4054/618 DEFLECTION AMP BOARD (672-0783-02) MODIFICATION #M39710 & #M38624

Figure 1 #M39710; Schematic 9-2 4054 Service Manual (070-2839-00)
Deflection Amp; SLU Sensor Circuitry

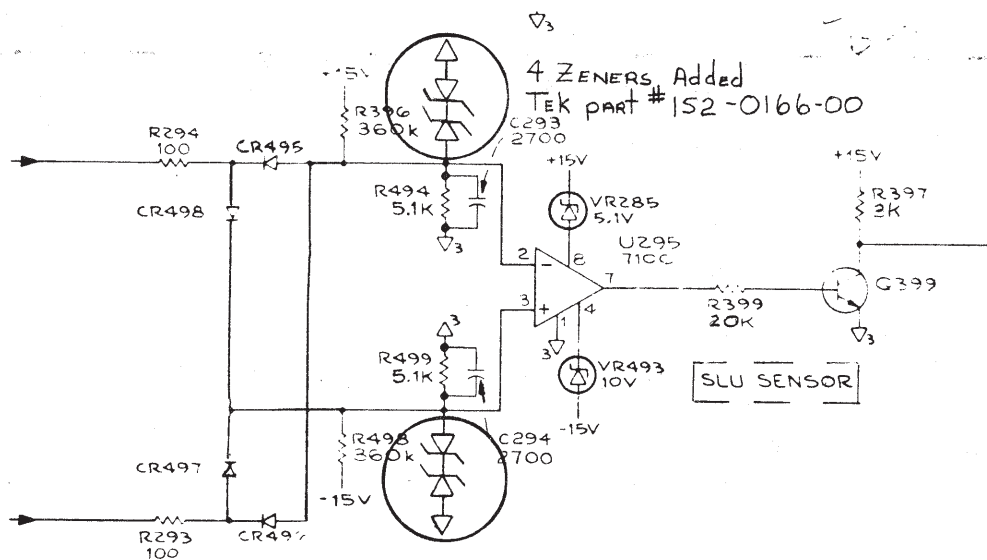
Some 4054s demonstrate graphics break-up while operating in the refresh mode. There was a correction to the Deflection Amp of the 4054 only to solve the refresh graphics break-up (672-0782-02 level board & below). The modification number is #M39710 and the board level changed from -02 to -03 and was implemented in 4054s between serial numbers B010354 to approximately B010600 (refer to figure 1). The -03 level board is not compatible with the 618, and further evaluation of #M39710 proved that it did not correct all 4054s, therefore the implementation of this modification was dropped.

Figure 2 #M38624; Schematic 9-2 4054 Service Manual
Deflection Amp; SLU Sensor Circuitry

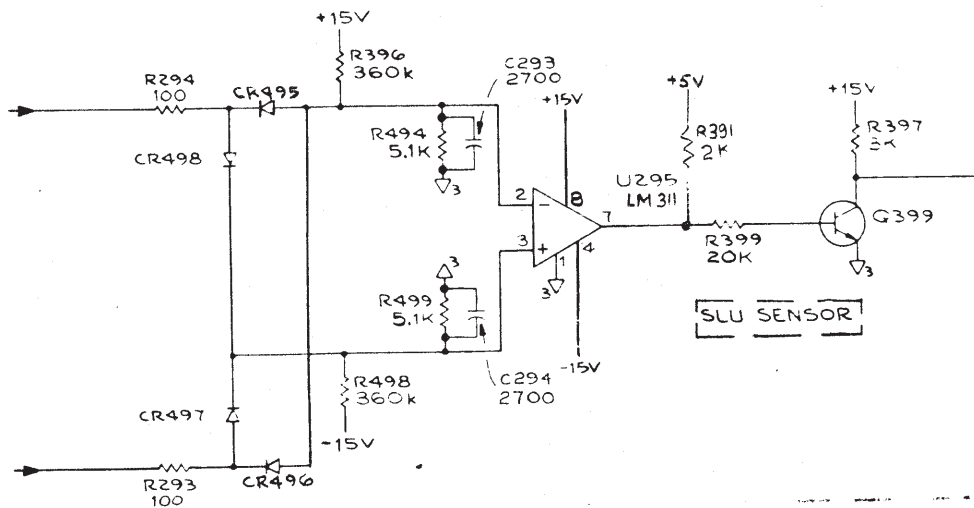
Modification #M39710 has been superseded and replaced by modification #M38624. Change #M38624 addresses both the -02 and -03 level Deflection Amp for both the 618 and 4054. This change is being implemented in both the 618 and the 4054 Deflection Amp and rolls both the -02 and -03 level boards to a -04 level board. There is a kit available which includes the instructions for the implementation of #M38624 and the kit number is 040-0977-00. In addition to correcting the refresh graphics break-up this new modification solves the insufficient resolution of the hard copy gain trim due to extreme range of the variable resistors. (Figure 2)
